Issued by
Haldex Brake Products AB

Product affected
ModulT ADB

Title / Subject
WARNING: Hazardous, unauthorized brake pads

Reg No.
HDX1-59-1061

Fig. 1: A brake pad for the ModulT air disc brake is shown above. In the brake pad, the standard hole size is depicted to the left, and the enlarged hole is shown to the right.

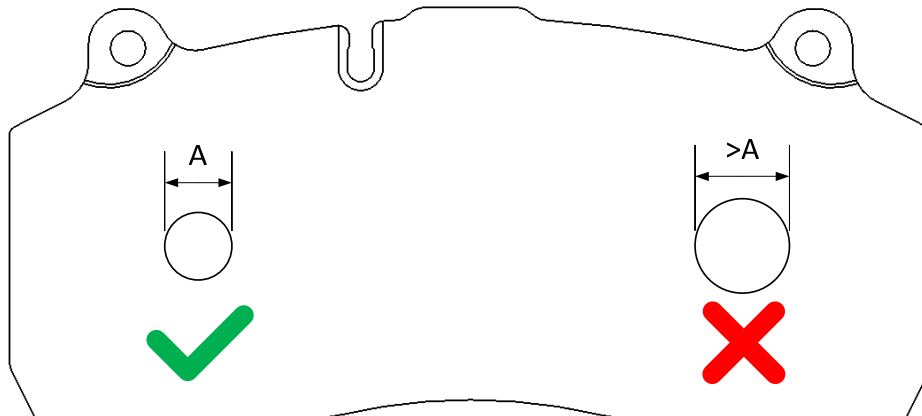
Unauthorized spare part brake pads for the Haldex ModulT disc brake, sold under the name Haldex DBT 22 LT and SBS2220 by SAF Holland, have been found in the market. These copies have larger holes in the backing plate of the brake pads, see Fig. 1 below, and do not provide the required amount of support to the projections on the thrust plate and whole mechanism as Haldex genuine spare parts.

Haldex ModulT disc brakes equipped with unauthorized brake pads have in tests shown the acceleration of the thrust plate to be significantly higher, and have been found in failed brakes having broken follower pins. This can cause the disc brake to lose the ability to brake! If non-validated spare parts are fitted, this not only invalidates any product warranty but also jeopardises the safe operational function of the brake. You can contact the Haldex Technical Support if you have any questions, see the Haldex website (<https://www.haldex.com/en/Europe/services-and-support/distributor-and-service-center-search/>).
